110 JERVOIS QUAY, WELLINGTON
CPTED STATEMENT

Issue. 17 February 2022

- 1.1. This Crime Prevention Through Environmental Design (CPTED) Statement supports a Resource Consent application and AEE prepared by Urban Perspectives Limited, on behalf of Michael Fowler Centre Development Limited Partnership, for development of a site currently known as the Michael Fowler Centre Car Park located at 110 Jervois Quay (121 Wakefield Street) in the Wellington CBD.

FIG 2A Existing Permeability (Wraight³ 26.11.21).

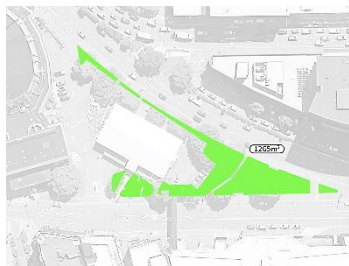
- v. the existing poor permeability of the site (**FIG. 2A**) due to the Jervois Quay edge;
- vi. proposed improved permeability supporting formal cross links (**FIG. 2B**);
- vii. and **FIG. 2C** shows the proposed through-site connections in a diagram taken from a 2014 Design Brief prepared for Wellington Waterfront/WCC which has also been used to guide this project.

FIG. 3. Ground Floor.

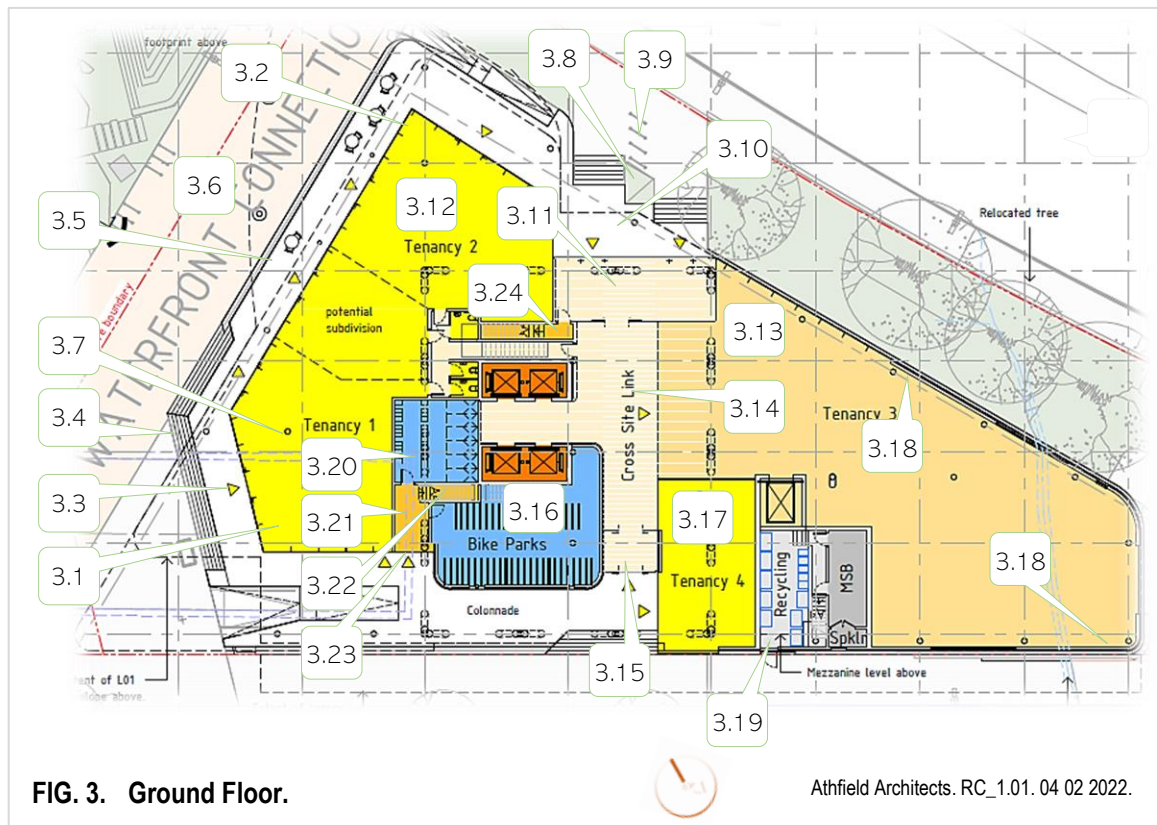
- ✓ Clear views through and around the west and north corners [3.1], [3.2] of the building.
- ✓ Slim columns [3.3] eliminate concealed lurking.
- ✓ Designed to sit on, pause by, and activate steps [3.4] and plinth edge [3.5], encouraged by promenading on the waterfront connection [3.6] and the nature of the occupancy in Tenancy 1 – particularly if there is

- ✓ Good supervision from inside Tenancy 1 [3.7] and potential activation via fully glazed façade.
- ✓ Two sets of generous stairs [3.8] help to provide entry/exit choices and maintain separation from people pausing on them.

- ✓ Public cycle rack [3.9] in clear view for natural supervision.
- ✓ Simple, legible, and wide entrance-way [3.10] with supervision from wind lobby [3.11], Tenancy 2 [3.12], and Tenancy 3 [3.13] – discourages soiling and unwanted occupancy/rough living associated with smaller entry/exit recesses.

- ✓ On the northern side, the wide steps and wind lobby knit well into, and align with the proposed crossing zone over Jervois Quay to link with the Waterfront. The entry matches the crossing zone and naturally channels the public through the building’s “cross-site link” [3.14] towards the important Opera House Lane link.

- ✓ The southern entrance [3.15] to the through-building cross-site link matches its northern counterpart. Both the colonnade and the curved wall from the cycle park [3.16] help to articulate the entrance. As with the northern entrance, there is potential for natural supervision from the active edges of Tenancy 4 [3.17].

- ✓ The northern and southern entrances will be access-controlled afterhours.
- ✓ It is anticipated that suitable lighting [200 lux] of the main entrances from within their respective wind lobbies will assist with wayfinding and legibility, and deter undesirable uses.

- ✓ It is anticipated that the four lifts will be card access controlled, and that the doors at the base of each of the fire stairs e.g. [3.22] and from the fire stairs onto each floor, will be card access-controlled as well.

- ✓ Glazed curtain walling around perimeter of all tenancies (e.g. [3.18]) extends to the ground without any horizontal transoms that invite informal seating, which can lead to unwanted informal occupancy and consequential damage.

- ✓ The secure external door to the recycling space and MSB door [3.19] is located at the building edge to avoid a recess.
- ✓ Access to the recycling and MSB areas are self-contained and do not provide access to the building core and circulation –

- ✓ similarly the End-of-Trip [3.20] and Bike Parks area [3.16] are self-contained and do not provide direct access to the core or main lift lobby [3.21].

- R It is recommended that an external, access controllable door onto Wakefield St (at [3.23]) be provided for the lobby serving the EOT [3.20], Bike Parks [3.16] and the south stair [3.22]. This is advisable in order to:
 - secure what would otherwise be a potential entrapment space presenting a risk to personal safety; and prevent unwanted occupancy (including rough sleeping), and soiling;

- importantly also, maintain access security for the entire south stair core albeit it would be preferable if there was an access-controlled door at or close to the commencement of the stair as is achieved with the north stair [3.24].
